Subject: Core Operating Limits Report Revision - LDC 02001

Grand Gulf Nuclear Station  
Unit 1  
Docket No. 50-416  
License No. NPF-29

GNRO-2002/00026

# **Grand Gulf Nuclear Station Core Operating Limits Report**

Figure 4-4 APRM Flow-Biased Simulated Thermal Power – High Scram Allowable Values for Two-Loop Operation

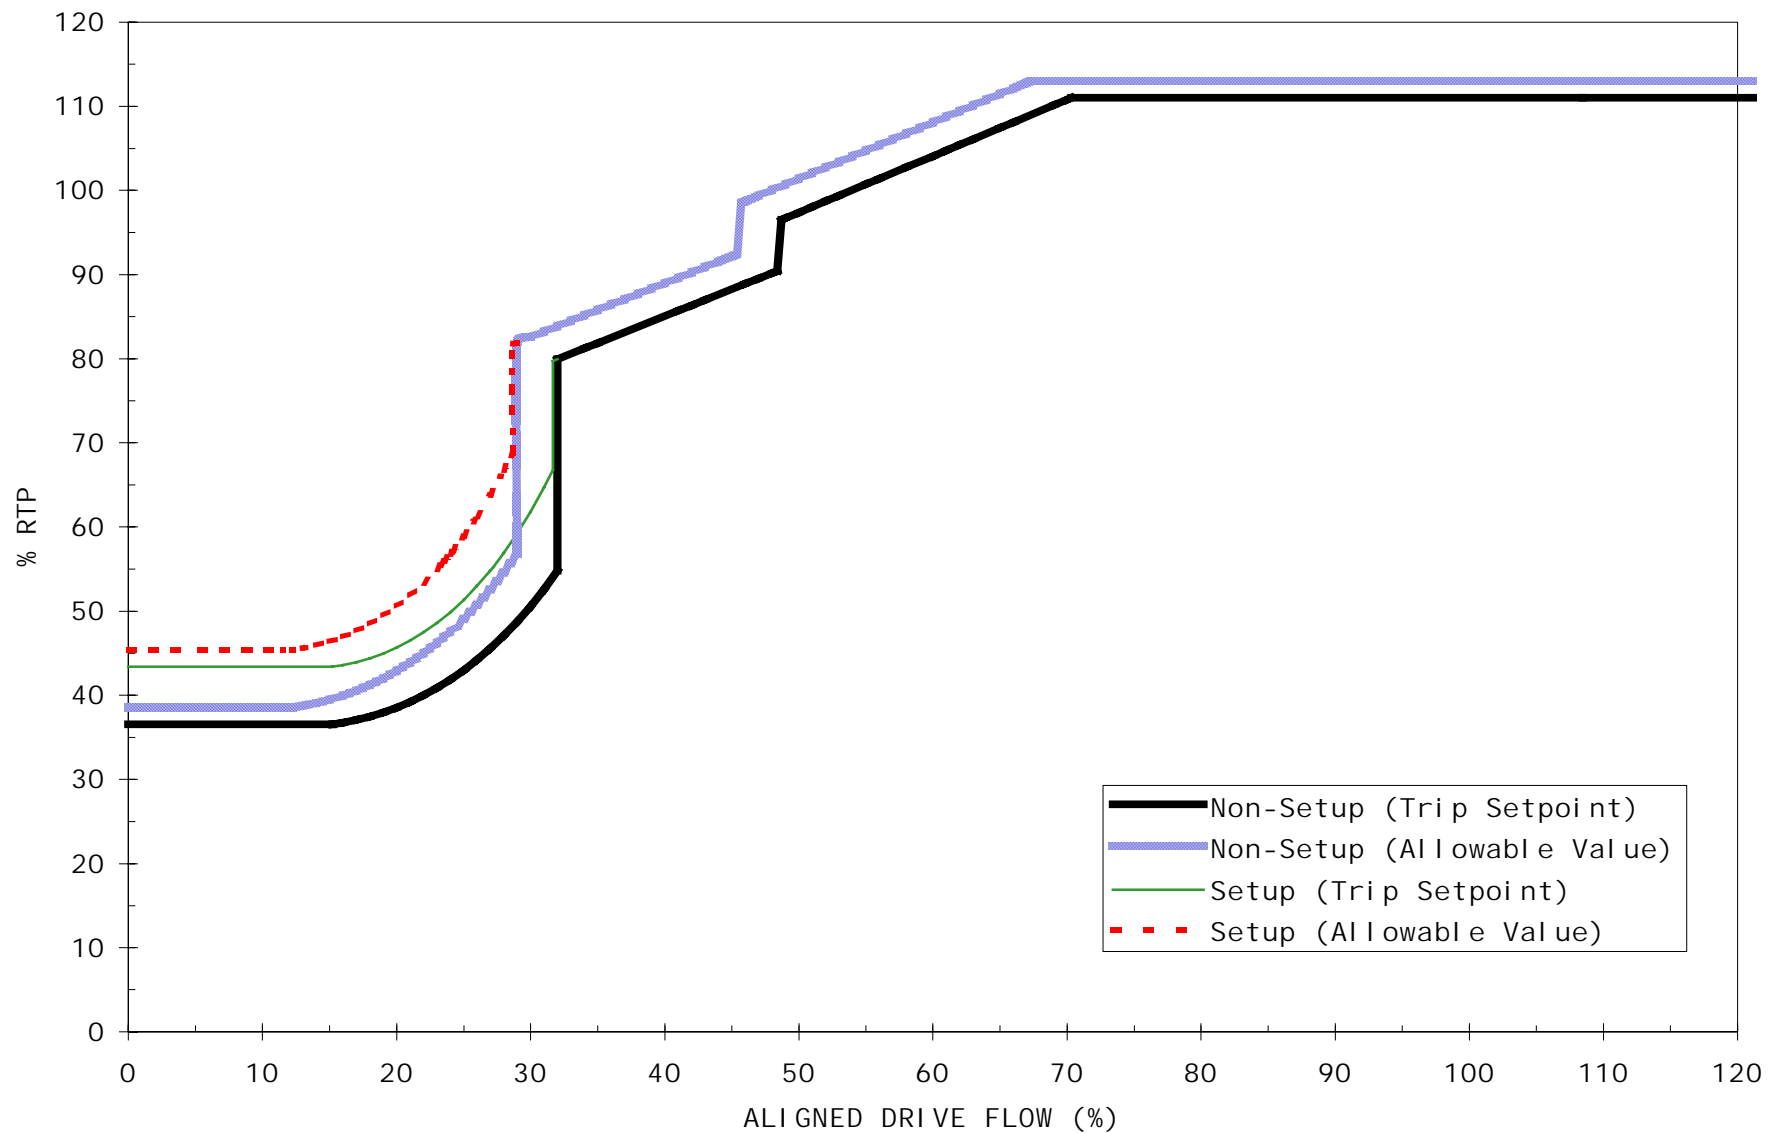
This change incorporates the Core Operating Limits Report (currently Engineering Standard MS-48.0) into Volume 1 of the Operating License Manual (OLM). The COLR is now a stand alone License Basis Document. Engineering Standard MS-48 is being cancelled. This change also resulted in a revision to COLR Figures 4-4 and 4-5 which were updated with additional information which was represented in Figures 3.3.1.1-1 and 3.3.1.1-2 located in Appendix 16B.1 of the Updated Final Safety Analysis Report. This added information was previously reviewed and approved via LDC 98037 which implemented Technical Specification Amendment 141.

This revision places the COLR in the same Operating License Manual binder as the Technical Specifications. Also, this change will require the COLR to be controlled and updated the same way other License Basis Documents are and will result in elimination of duplicate COLR curves currently represented in the Technical Requirements Manual and UFSAR. In the past these duplicate curves have created confusion and required extra effort to keep all of the curves up-to-date with one another. This change also resulted in a revision to Figures 4-4 and 4-5 which were updated with additional information which was previously represented in UFSAR/TRM Figures 3.3.1.1-1 and 3.3.1.1-2. The additional information added was previously reviewed and approved via LDC 98037 which implemented Technical Specification Amendment 141.
